Kilburn Grange Park

First Pre application Advice

Building heights on park elevation

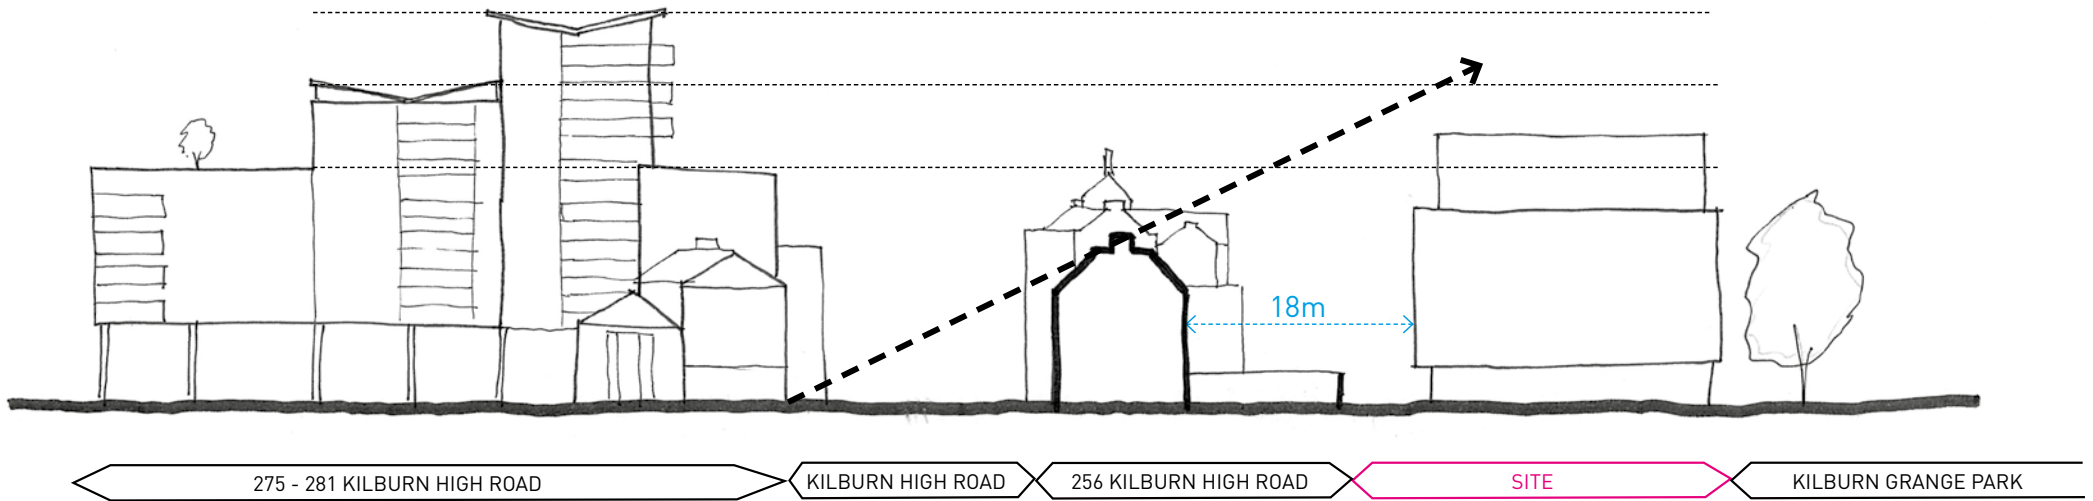
- The proposed building would have the most impact on views from Kilburn Grange
- The Council's urban design officer is concerned that the proposal appears monolithic in relation to the finer grain of the surroundings and would harm the views from the park. The proposal would result in a substantial change to the buildings which form the boundary to the park. The bulk of the proposal should be reconsidered and designed to break up the views from the elevation facing the park. The design is currently shown as a simple and repetitive design across the main five storeys, the upper two storeys are proposed in a lighter weight material. Although the use of lightweight material can be helpful, the upper two storeys would still be visible and read as part of the form of the building.

- The total height of seven storeys is considered to be too high for this site, given the width of the building and the site coverage proposed. It is considered that the height of the proposal would result in an over prominence in views from the park. The height of the proposal is considered to be excessive and this would be exemplified by the width of the site and bulk of the proposed building. It is advised that the height should be reduced. The height on the corner should be no more than 6 storeys.

- The design needs to add vertical articulation to the elevations in order to help break up the overall bulk and massing .
- No. 274 Kilburn High Road, The Black Lion Pub is a grade II* listed building. The site adjoins the boundary of the listed building, therefore the setting of this listed building will need to be fully assessed.

The precedent set by the residential block at the opposite end of the park supports a six storey building to complete the bookend.

The massing of the proposal decreases in the middle so as not to dominate the vista from Kilburn Grange Park and so that we join the neighbouring buildings at a similar height.

Emphasising verticality where possible will further break down the bulk of the building.

Proposed Ground Floor Plan: Option 1
Total Commercial Area: 1542 sqm

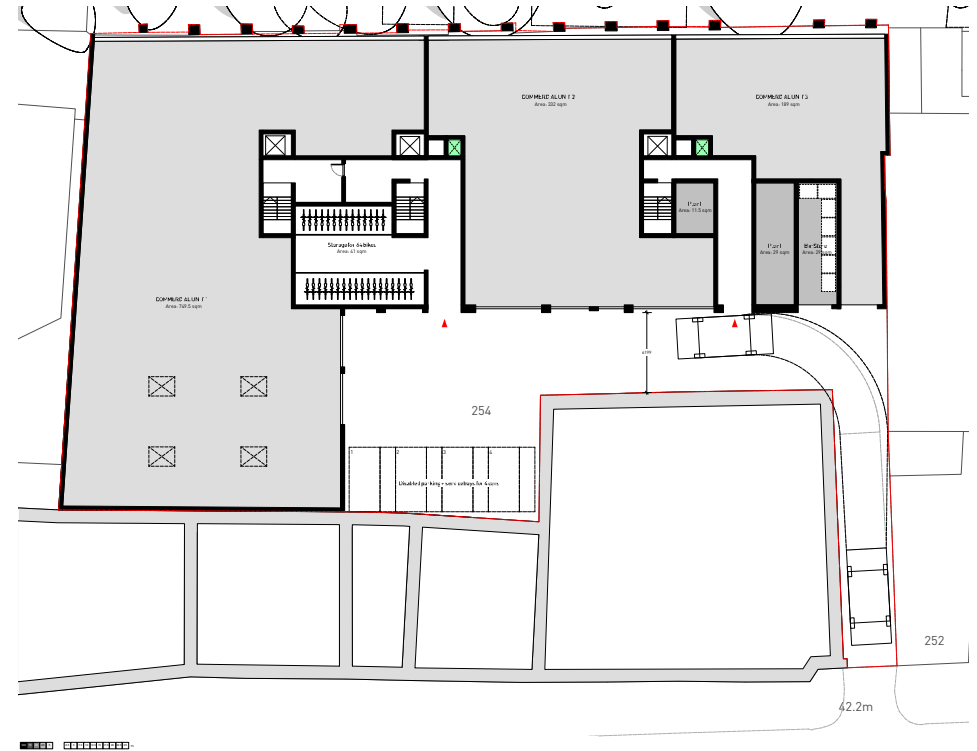
- Proposed redevelopment would need to provide an equivalent size and quality of general industrial space to replace that currently on the site.
- Any reduction of parking on site would be welcomed under planning policy.

- A loading bay and sufficient turning space should be provided within the site so all vehicles can enter and leave in a forward gear. Access for refuse vehicles should also be made available.

Following the feedback received from the first Pre-Application submission we looked at the possibility of providing a 'like-for-like' area of commercial space. This option leaves very little open space at ground floor level, and there is no space for the required vehicular turning area.
